To: T10 Technical Committee
From: John Lohmeyer, LSI Logic Principal Member of T10
Subj: Proposal to change MSE high-impedance current specification in SPI-3

The May '99 SPI-3 working group requested that I develop a written proposal regarding relaxing the High Z input characteristics of MSE devices (i.e., their input characteristics when they are not driving the bus). After posting rev 0, I received some suggestions for improvements from Claude Pattein via email. I've included those changes and a couple editorial changes in rev 1 of this proposal. I propose the following changes be made to SPI-3 rev 7:

Figure <new> - MSE device high-impedance input characteristics

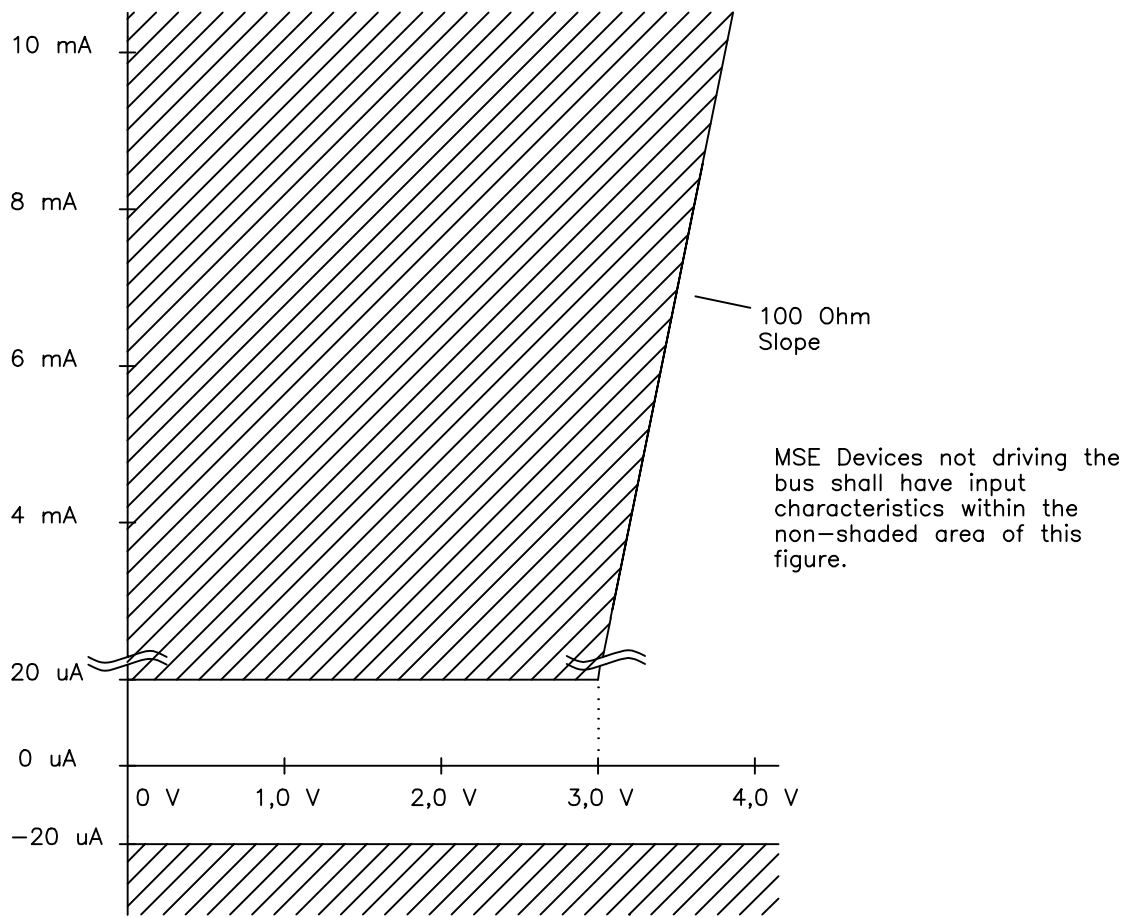
Modify table 16 as shown:

Value	Maximum	Notes
MSE current magnitude	See figure <new>	Measured from + or - signal $0 < V_{IN} < 4,1$ V to local ground for each signal pin.
LVD current magnitude	$\pm 20 \mu\text{A D.C.}$	Measured from + or - signal $0 < V_{IN} < 2,5$ V to local ground for each signal pin.

Add a new figure under table 16:
